Re: **Notice of Violation**
Turkey Hill Minit Market #705 / Franklin County
Permit Number: 4GC03185*AG

This letter is written regarding the storm water inspection that I conducted on May 24, 2011, at the Turkey Hill Minit Market #705, located along Morse Road, in Columbus, Ohio. Please provide me with your General Storm Water Permit number for this site. This office has not located your permit. The reason for the site inspection was due to several complaints of sediment-laden storm water blocking the Morse service road and safety issues with the flooding of the street. Please consider this a formal notice of violation. I noted the following issues at this site:

Turkey Hill Minit Market
Stabilize barren areas
Install erosion controls
Aurum Creek Watershed
May 24, 2014
Photo by: Greg Sanders

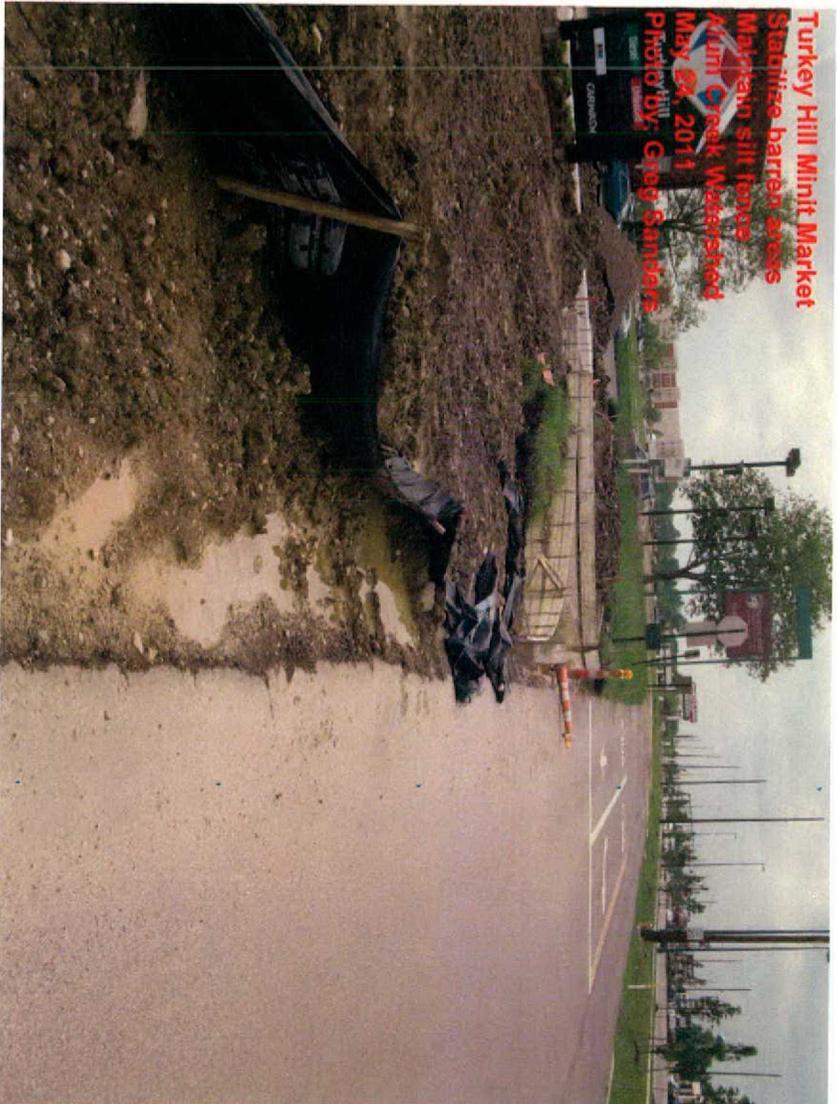
- Please be aware that erosion controls were not adequate for the site. The silt fence was not properly installed and large sections were laying on the ground. The silt fence will most likely require a gravel berm to prevent the silt fence from failing again. If the current erosion controls fail again, it will be recommended to install sediment traps at the site. Please see attached pictures.

- Please be aware that the General Permit mandates specific permanent and temporary stabilization requirements. All disturbed areas which remain idle in excess of 21 days must be protected from erosion within seven days of the last earth disturbing activities. All areas of final grade must be protected within seven days. All earth disturbing activities should be clearly logged in your inspection reports to ensure the 21 day / seven day requirement is not violated. It appears construction is near completion and all disturbed areas are at final grade at this site. Please stabilize the barren areas immediately.
